**Re: Initial Engineering Review
WRPD Application – Harding Street TIP – Rte. 44
ADE Project #2518.29**

**WRPD Special Permit Application
Transportation Improvement Project
Harding Street (Route 44)
Middleborough, Massachusetts 02346**

**Re: *Initial Engineering Review
Earth Removal Permit Modification
G. Lopes Construction and Red Dog Cranberry, LLC
ADE Project #2518.30***

RE: W.R.P.D. Application: 150 South Main Street (M581, L4265)

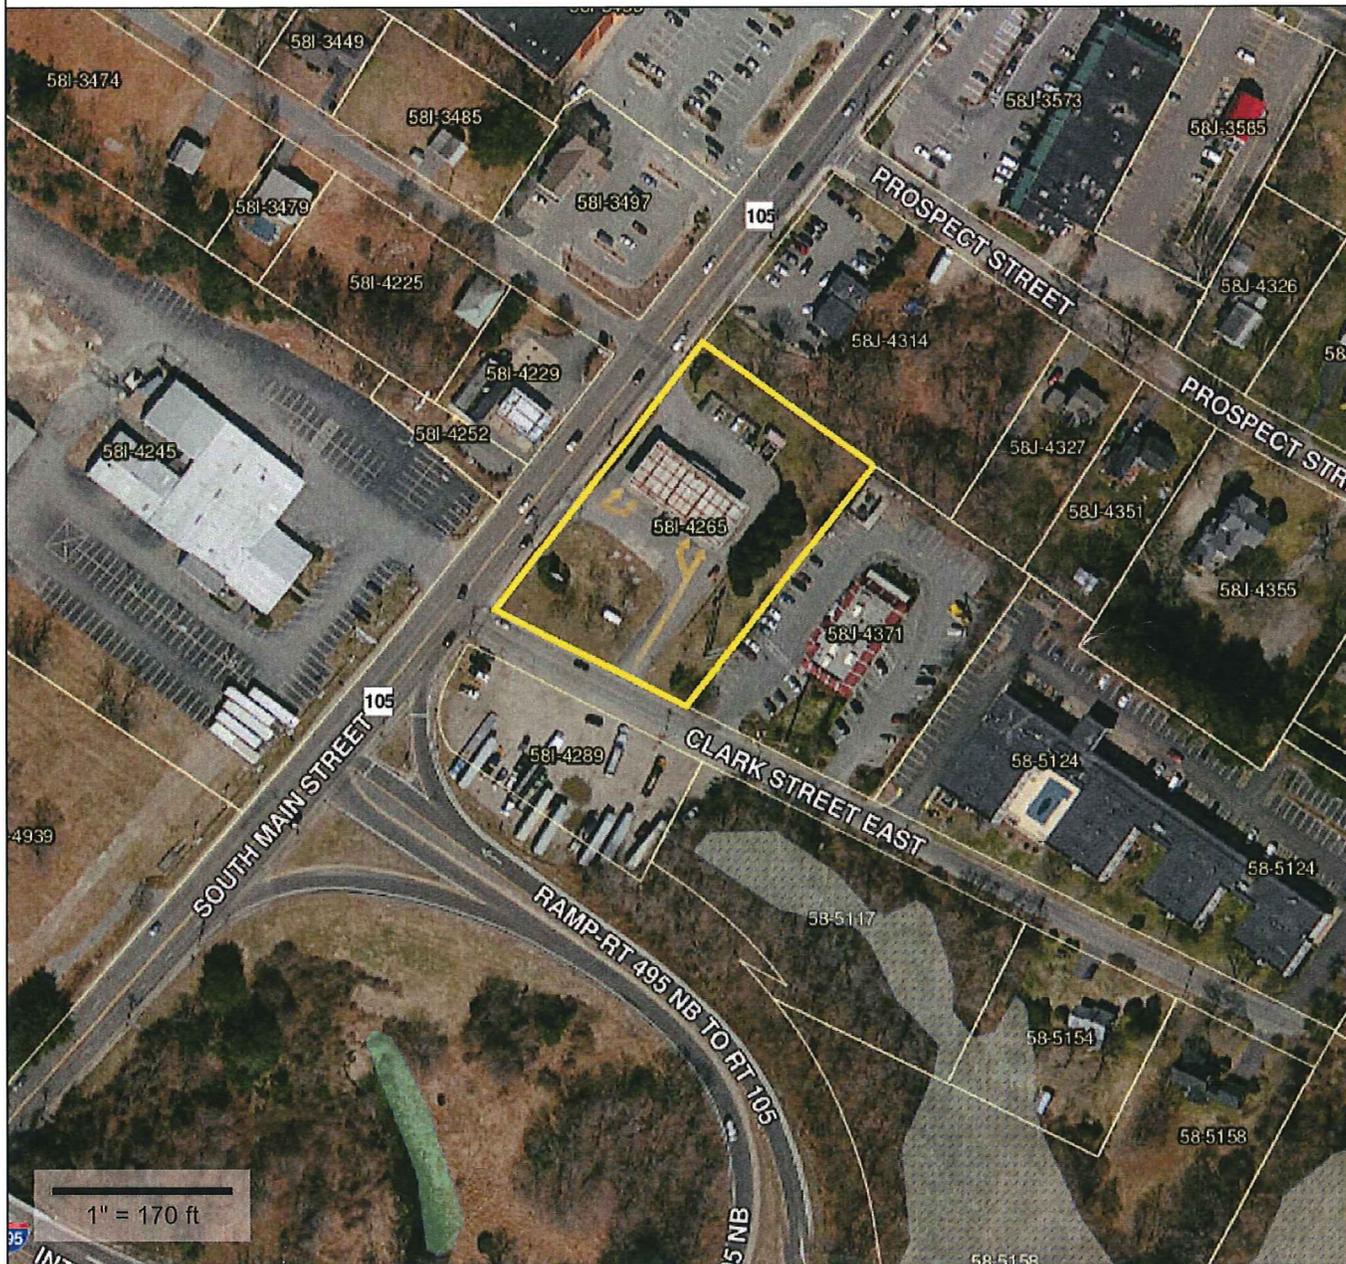
It would be helpful if the applicant can show that they are greater than 100-feet away from the wetland depicted on the attached wetland mapping from the town's Map Geo program. It appears that the proposed project is close to this wetland that is associated with the Nemasket River.
